Access Compliance Report Public Rights-of-Way (RR Crossings)

Intersection ID: 5967	Main Street: N_TRYON_ST	Location: N/A
ADA ID: 866AA833F736	Overall Compliance: No	Severity Score: 0.0
Codes/Mitigation Info/Possible Solution		Field Measurements/Component Compliance

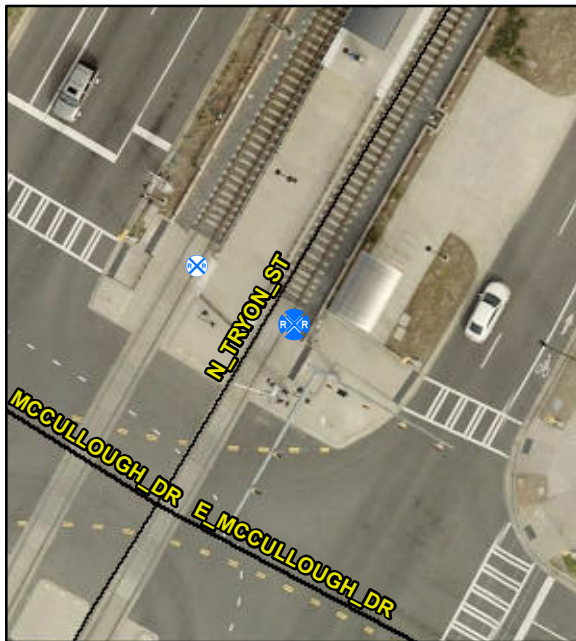
Compliance	Description	Data
Yes	DWS Provided?	Yes
Yes	DWS Contrast?	Yes
Yes	DWS Width (in)	Yes
Yes	DWS Length (in)	24.0
Yes	DWS Offset (in)	115.0
No	Pedestrian Gate?	No
N/A	DWS Outside Gate?	No
N/A	Rail Type?	LightRail
No	Flangeway Gap (in)	3.0
Yes	Sidewalk Width (in)	120.0

**Remove & Replace Detectable
Warning System. Provide Pedestrian
Gate. Remove & Replace Walking
Surface Adjacent to Rail.**
